# Wisconsin Department of Transportation

**Proposal #08: 2030-13-70, WISC 2020 321**  
**108<sup>th</sup> St**  
**I43 to Hank Aaron State Trail**  
**STH 100**  
**Milwaukee County**

This is Addendum No. 02, which provides for the following:

Addendum No. 02  
 ID 2030-13-70  
 Revised Sheet 668  
 June 3, 2020

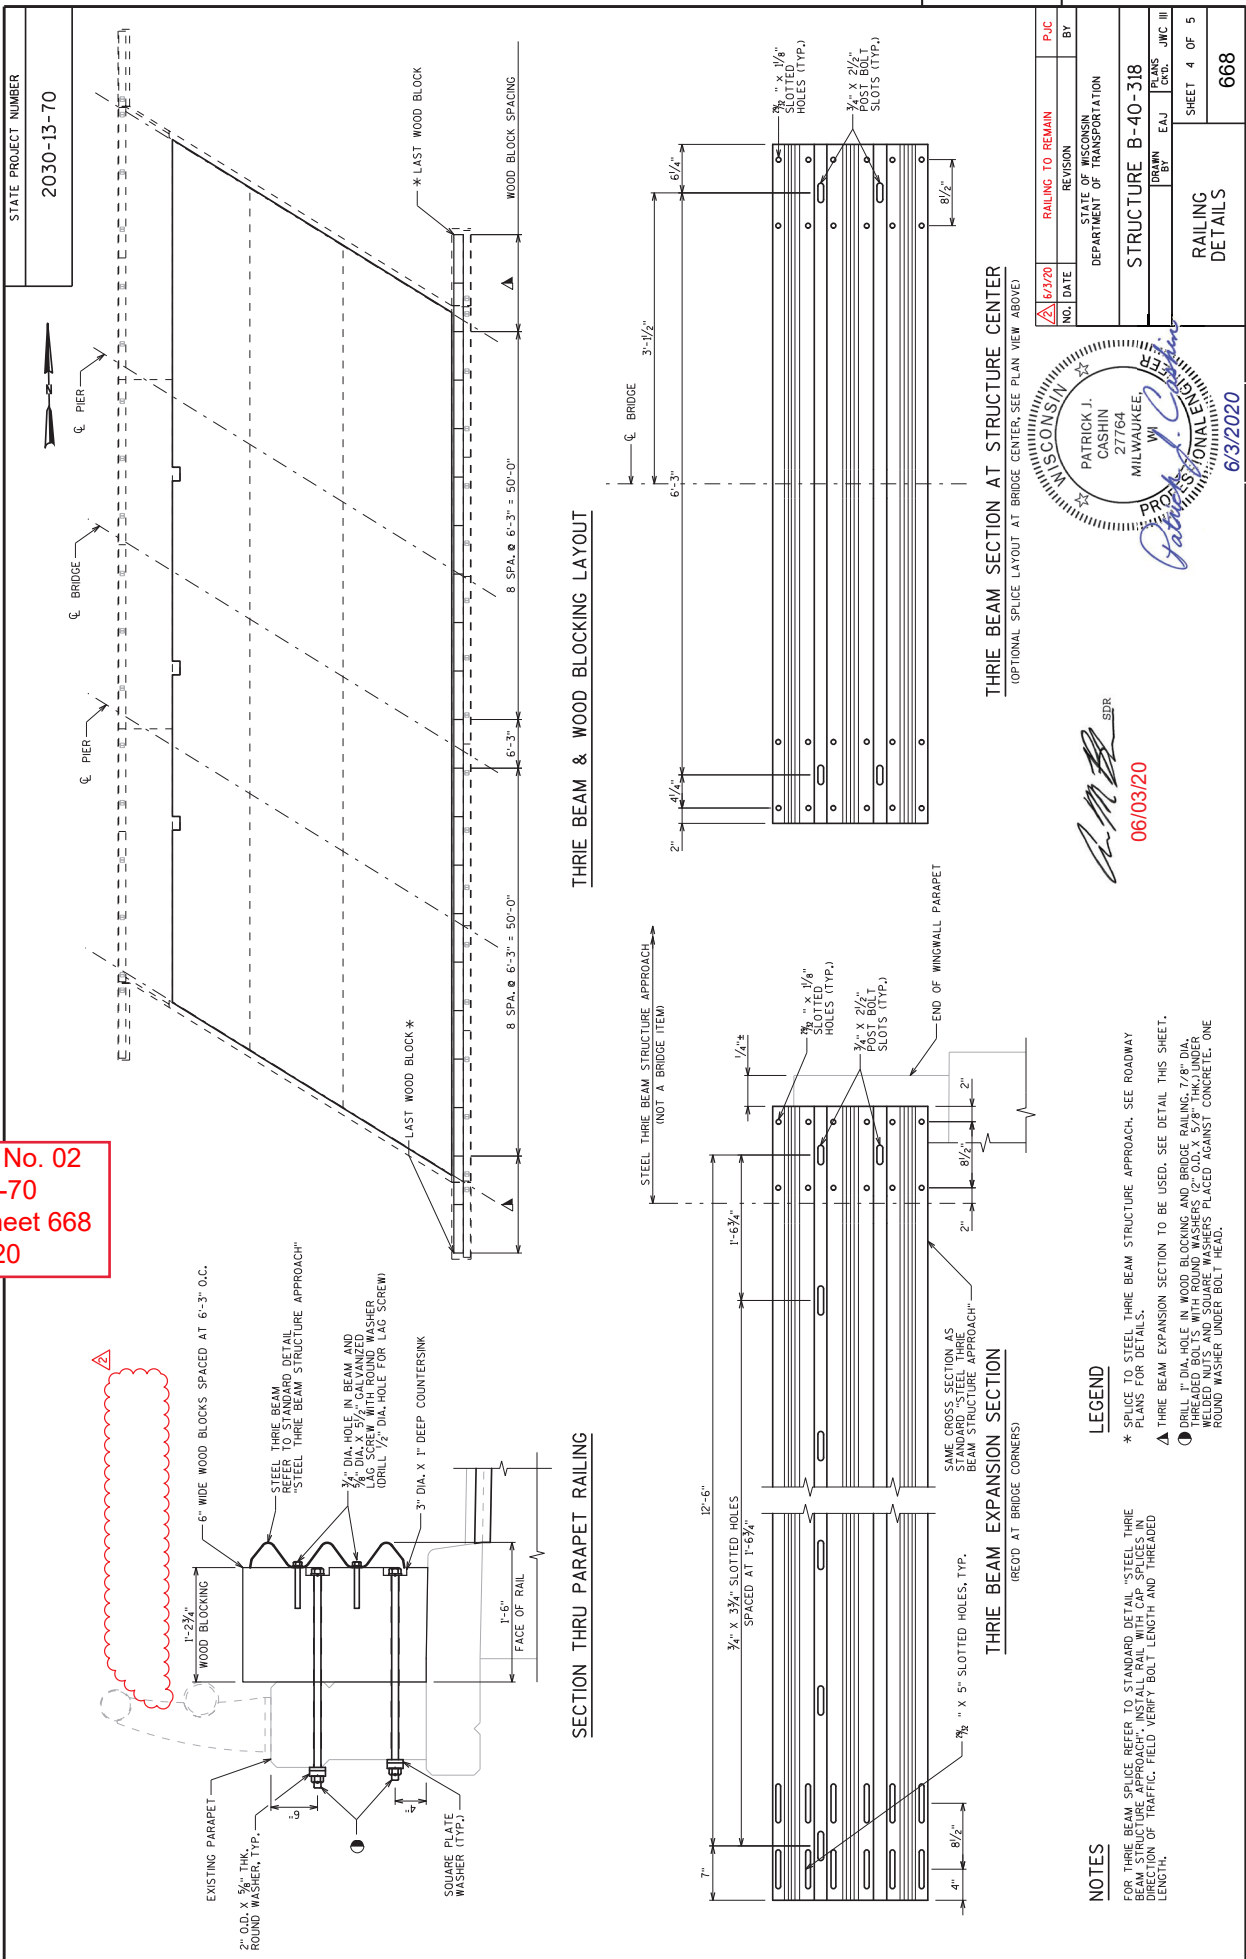
Revised Plan Sheets	
Plan Sheet	Plan Sheet Title (brief description of changes to sheet)
398	Revised "Drilled Tie Bars" quantity.
406	Removed "Concrete Collars for Pipe" column.
407	Removed "Concrete Collars for Pipe" column.
666 (2 of 5)	Structure B-40-318: Removed notes requiring tubular railing removal
668 (4 of 5)	Structure B-40-318: Removed notes requiring tubular railing removal
671 (2 of 5)	Structure B-40-319: Removed notes requiring tubular railing removal
673 (4 of 5)	Structure B-40-319: Removed notes requiring tubular railing removal

NO.	DATE	REVISION	BY
6/3/20		RAILING TO REMAIN	PJC
